Re: Homer City VOC Emission Reduction Credit Proposal
55 Pa. Bull. 7611 (Nov. 1, 2025)

**Re: Initial Plan Approval Application for Homer City Generation LP
No. 32-00457A**

Figure 6-9. Map of Terrain Heights Above Plume Height from CC Stacks

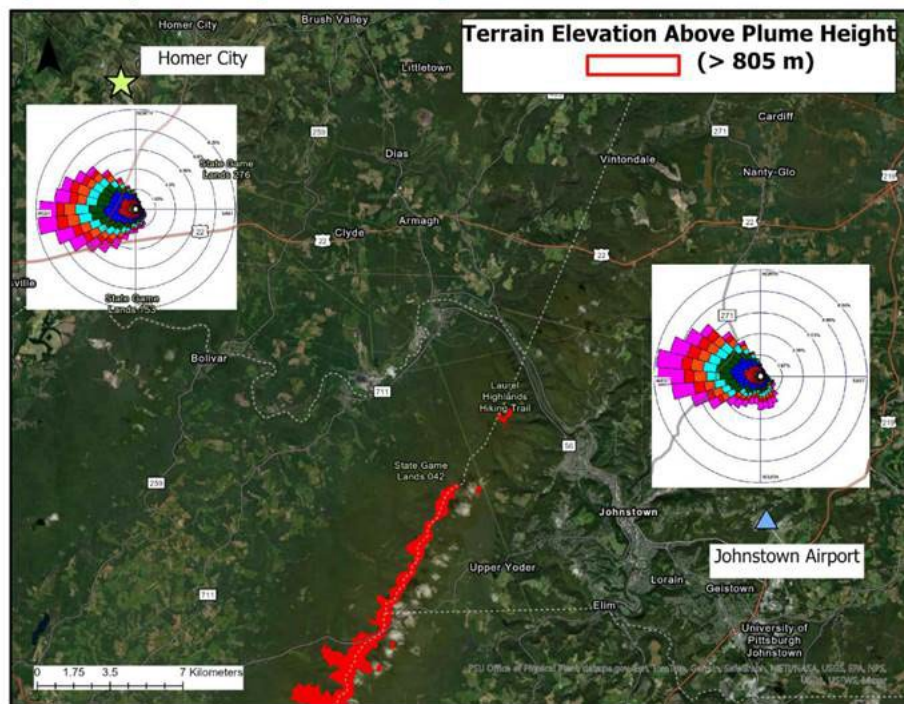
92, which confirms that the FT8s have 90 foot stacks while the combined cycle units have 190 foot tall stacks, Table 6-1, Application at pdf 91) of the FT8 units.

Since the impacts from the shorter, 90 foot stacks from the FT8's have not been analyzed, the conclusions presented in Section 6.6.3.2 that "...[W]ith the exception of a few rogue peaks along Laurel Ridge near the Laurel Highlands Hiking Trails, the rest of the surrounding terrain is below this level" are demonstrably unsupported. Thus, the map shown in Figure 6-9 excerpted below that only a few of the ridges shown in red will be impacted by the plumes from the Homer City plant is false. Far more than "a few rogue peaks" will be impacted by the plumes from the FT8 units.
